**BROOKE COUNTY PUBLIC SERVICE DISTRICT
BROOKE COUNTY, WEST VIRGINIA**

**PHASE IIC SANITARY SEWER LINE EXTENSIONS (ST. JOHN'S ROAD, DELTA LANE,
BAXTER ADDITION, ETTA LANE, MEMORIAL LAKES ROAD, MULBERRY DRIVE,
PLEASANT VALLEY LANE, WALKER MANOR DRIVE)**

ADDENDUM #1

JUNE 5, 2023

SHEET No. **16**

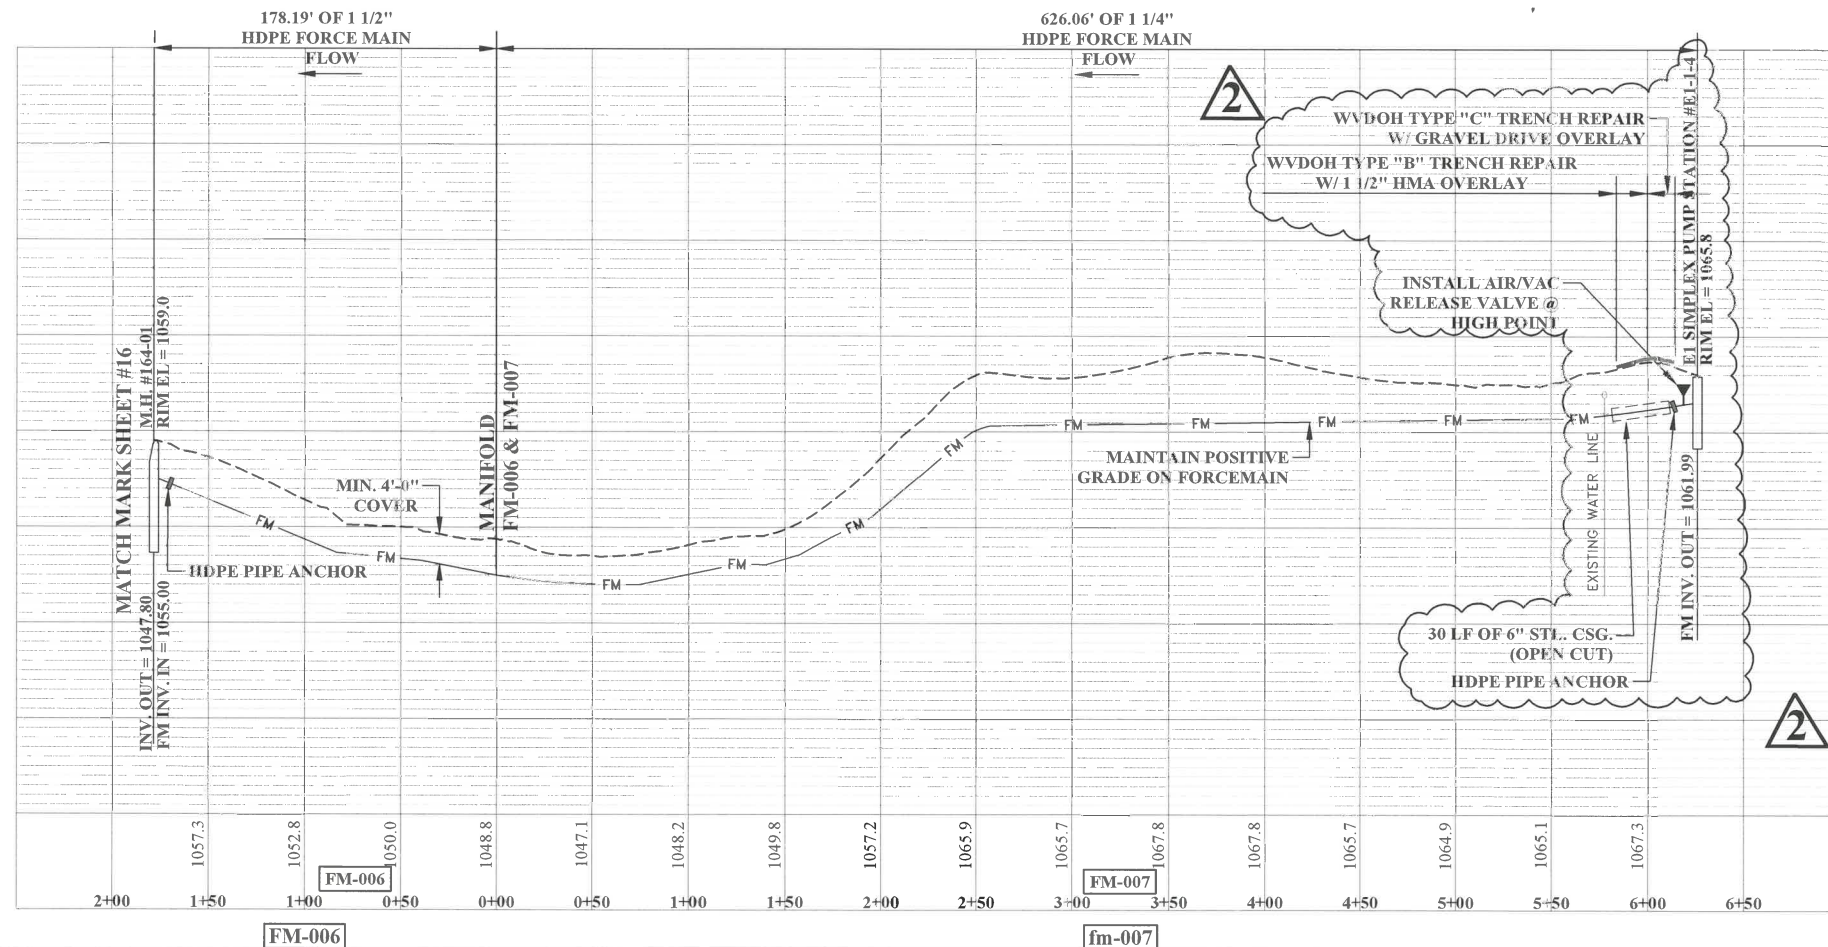
1. Plan Sheet 16 involves parcel #90 in which the E1-1-4 Grinder Station was slid towards the road approximately 20 feet due to ROW Negotiations.
2. Plan Sheet 23 has added a note to the sheet that the Contractor shall not disturb the homeowner's fence or turf yard on parcel #12.

SHEET No. 27

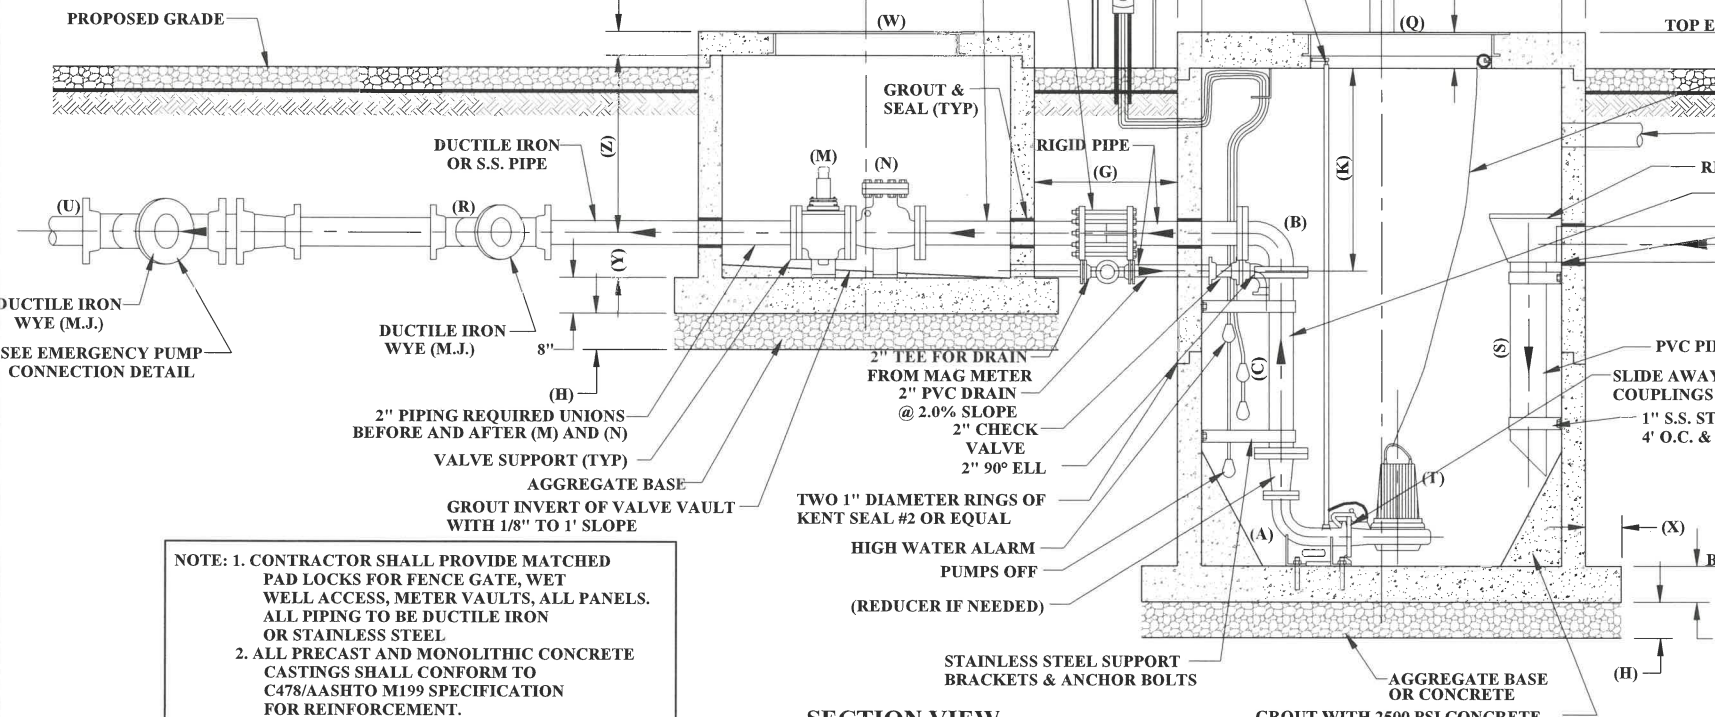
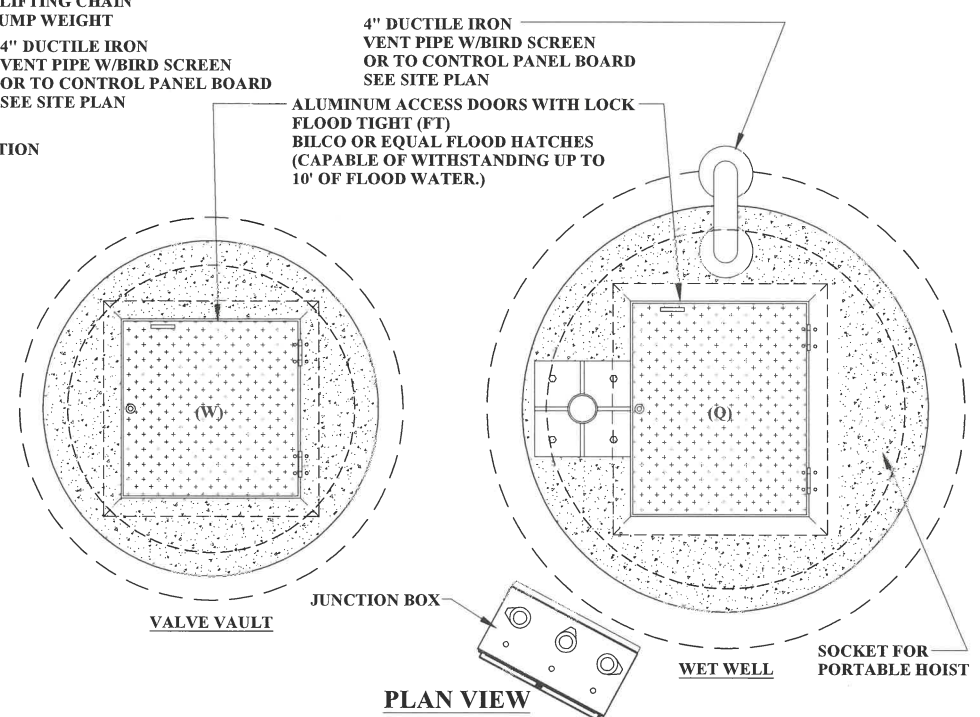
3. Plan Sheet 27 had the Valve Vault Diameter and the Wet Well Diameter dimensions flipped on this sheet and it has since been revised.
4. Detail Sheet D2 had the incorrect dimensions for the Manhole Lids. The revised Detail Sheet was added with the correct dimensions for the Manhole Lids.

On the three (3) pump stations, are the valve vaults meant to be five (5) foot wide?

Sheet 27 of the plans has been revised so the valve vaults for all three (3) pump stations are to be four (4) foot diameter vaults.

(G) DIMENSION	3'-0"	3'-0"	3'-0"
(H) DIMENSION	1'-0"	1'-0"	1'-0"
(I) DIMENSION	PER. MANUF.	PER. MANUF.	PER. MANUF.
(J) VALVE VAULT DIAMETER	4'-0"	4'-0"	4'-0"

SHEET No.
D2

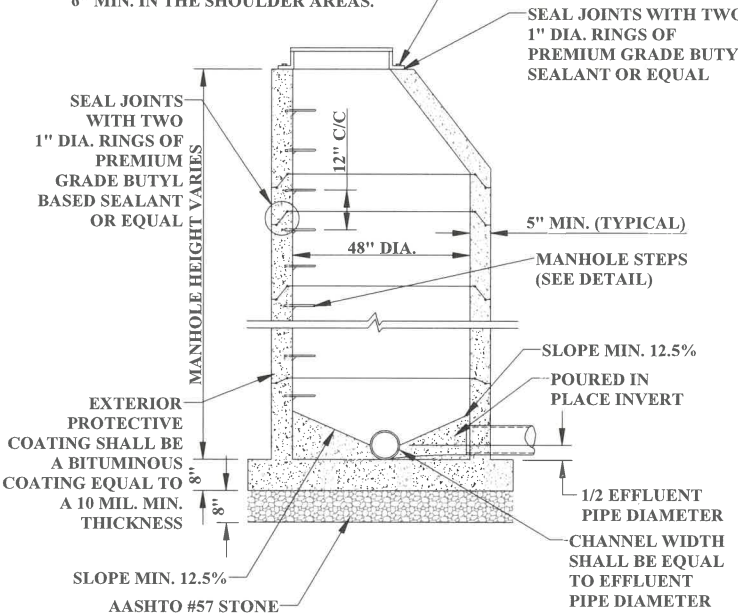
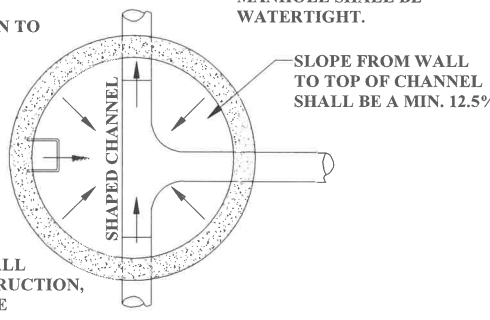
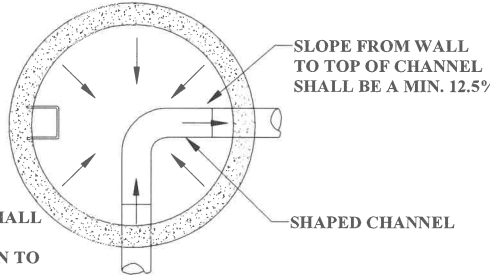
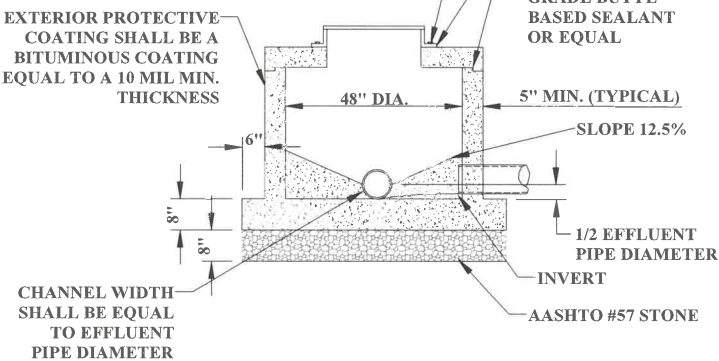
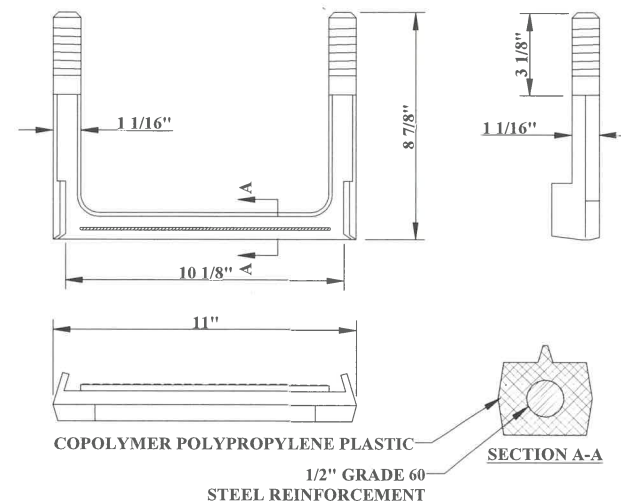
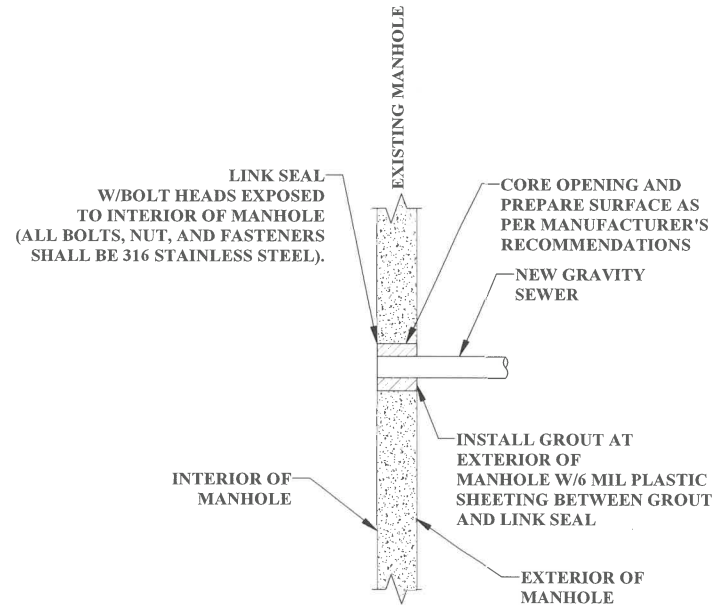
In the one file the watertight is a 1915-S1. The drawings show a 1916-F, which one do you want us to quote?

The manhole lid shall be the 1915-S1 model manhole. Sheet D2 has been updated and included with this Addendum to show the corrected dimensions to meet the specifications of the 1915-S1 model.

SHEET No. **D4**

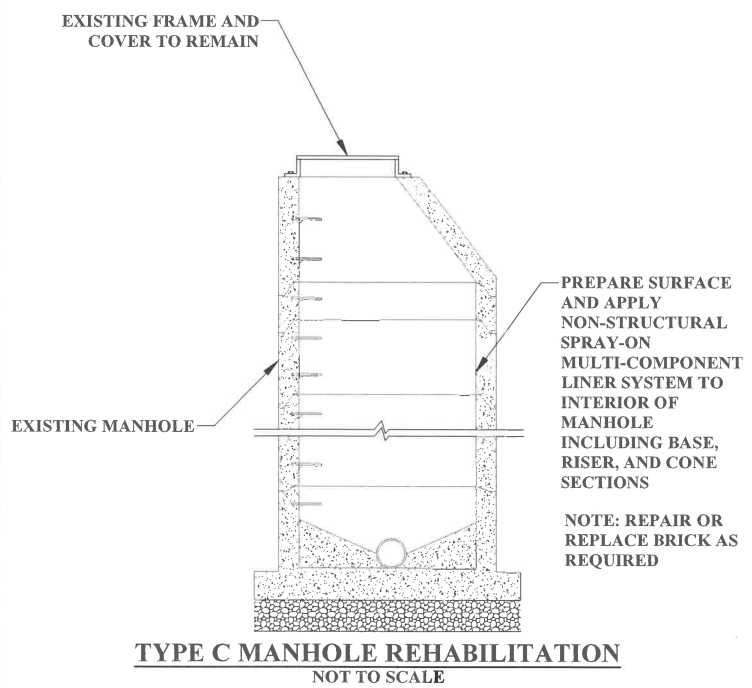
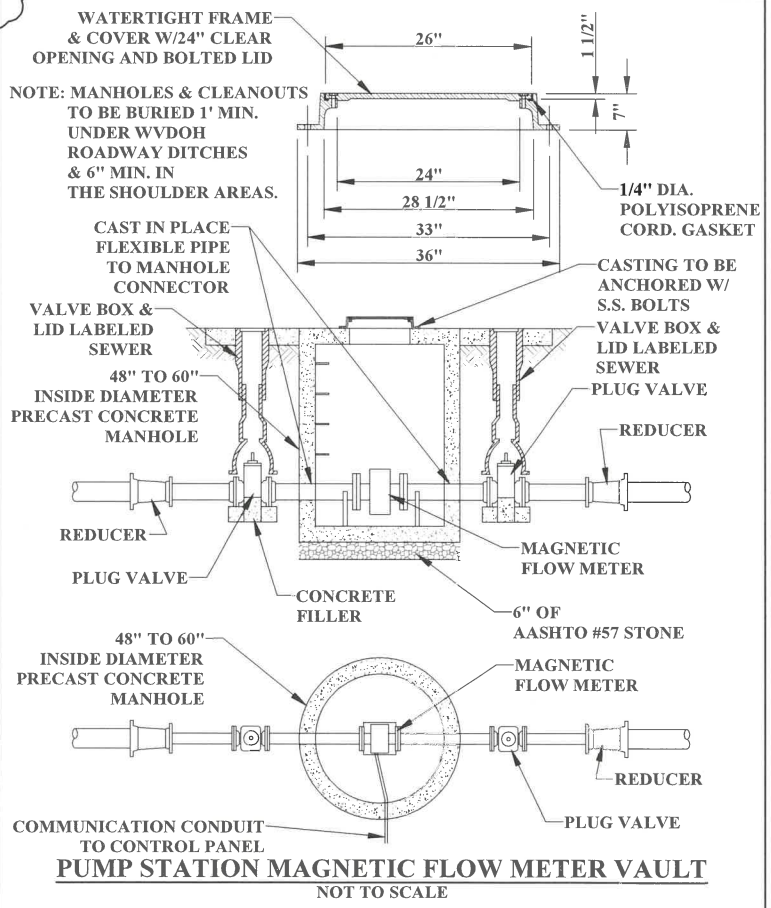
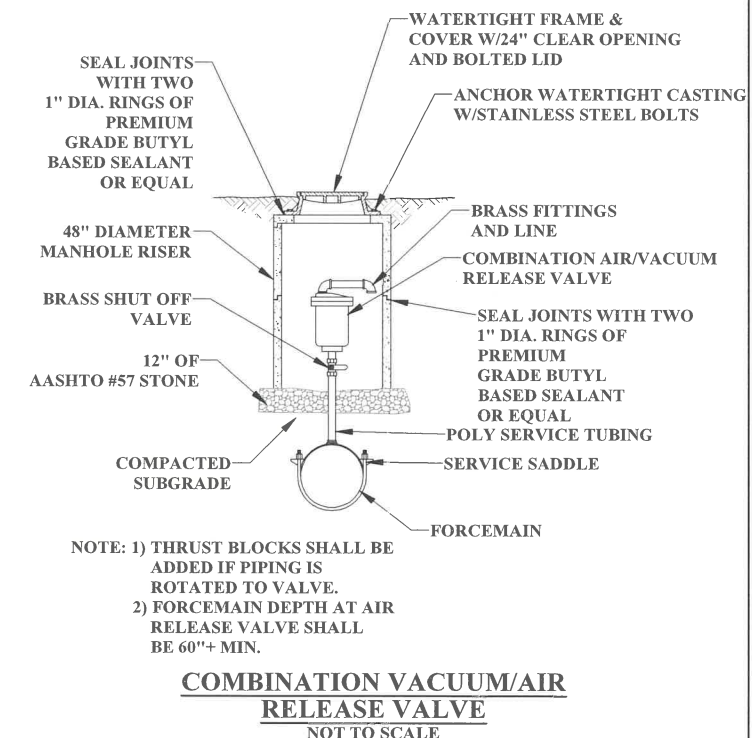
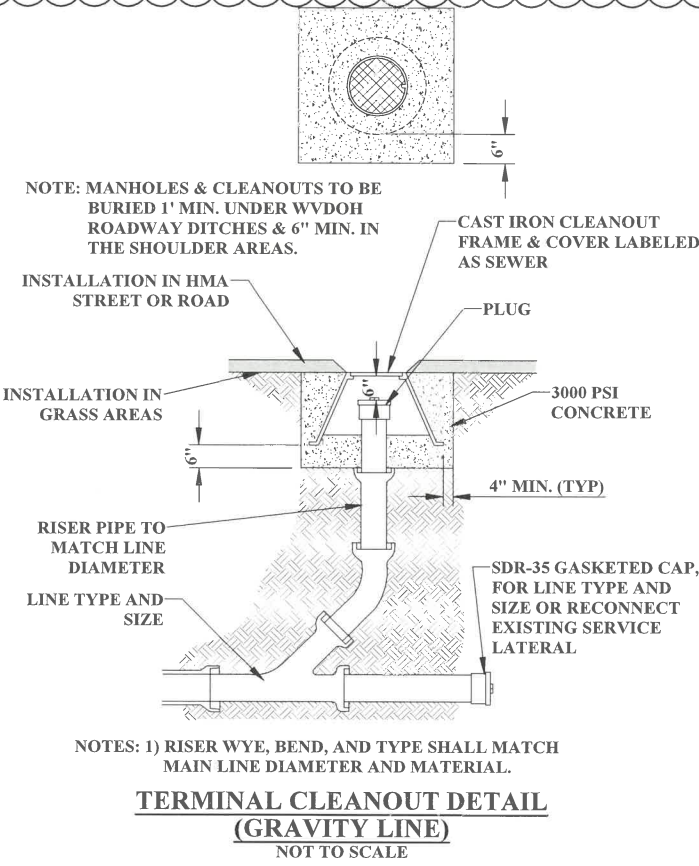
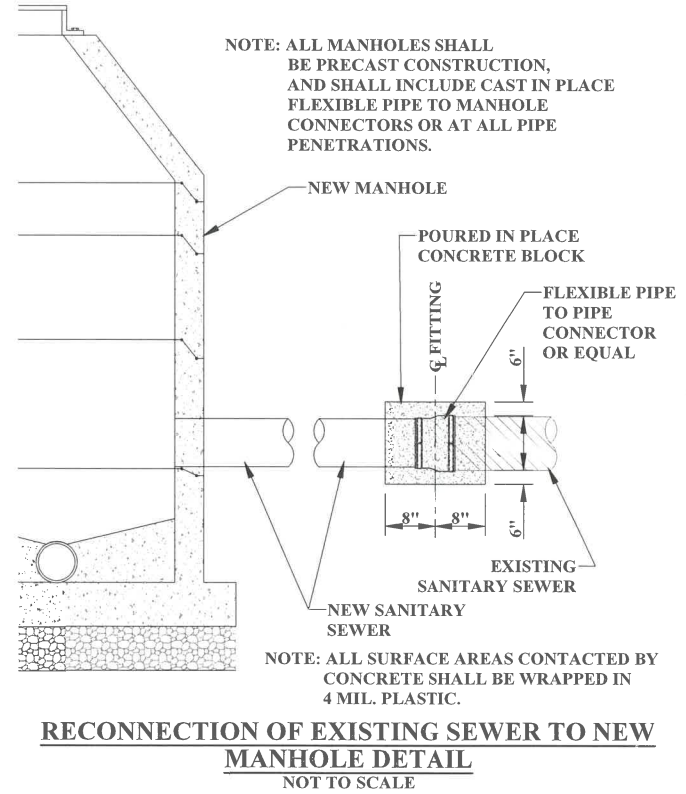
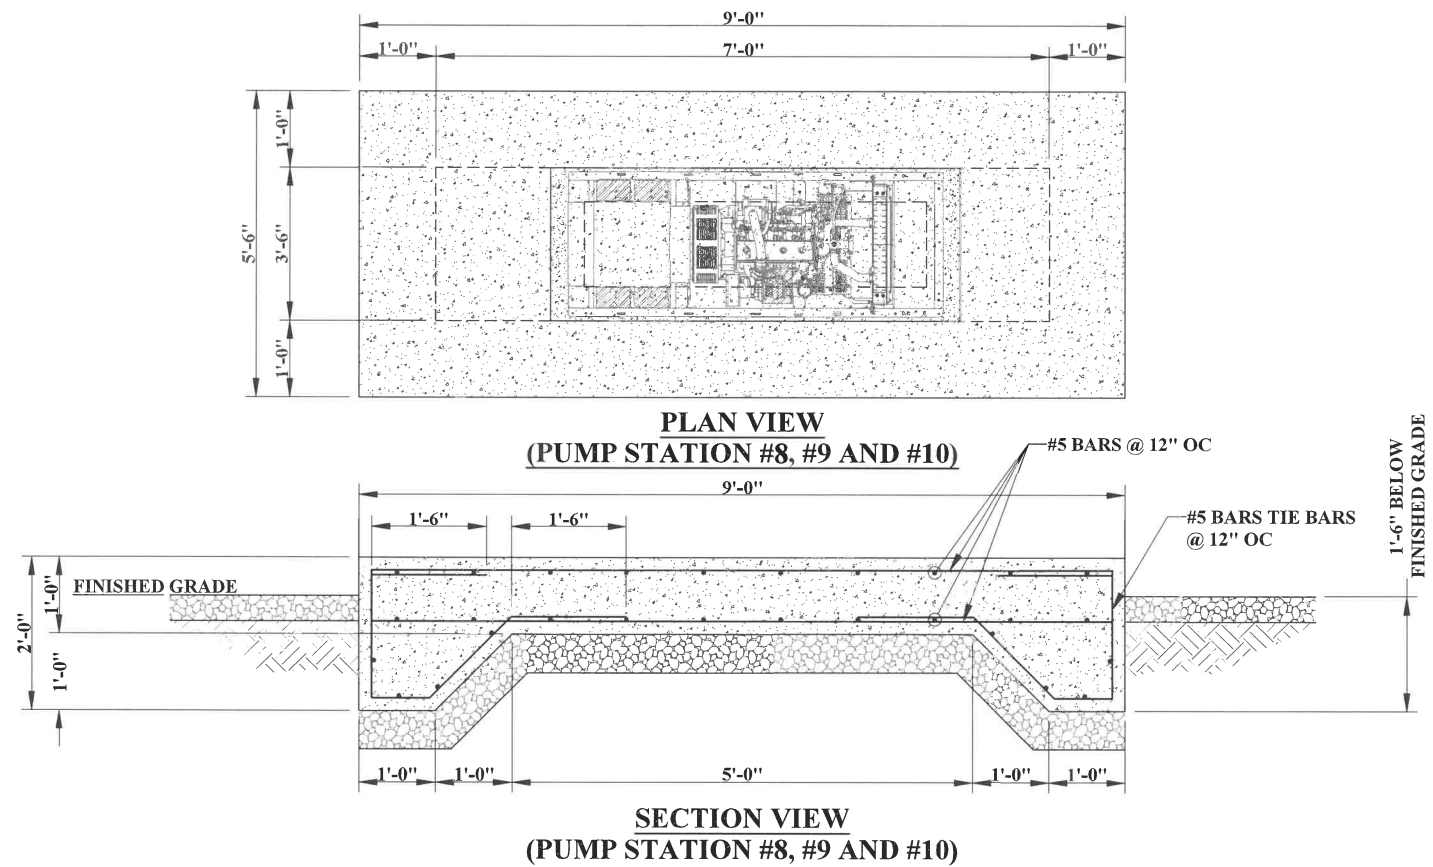
5. Detail Sheet D4 has been updated and revised due to an incorrect representation of the Customer Service Lateral Cleanout Detail for this project. It also includes the addition of the Pressure In Line Cleanout for 2" and Smaller Forcemain.

Do you have a detail of what is required for bid item 62, in-line pressure cleanout shown on page 17 of the plans?

What bid item are the Customer Service Lateral Cleanouts (Sheet D4) to be paid under? Or are these not required? Bid items 51-53 – Call out a Wye Service. The Detail on Sheet D4 has a 2-way Sanitary Tee. Please verify.

A detail for Pressure In Line Cleanout for 2" and Smaller Forcemain has been provided in this Addendum.

Customer Service Lateral Cleanouts are not required. The Wye Service connections on Bid items 51-53 are to use the detail on Sheet D4 shown as “Service Connections” that has been updated and provided as part of this Addendum, see revised detail.
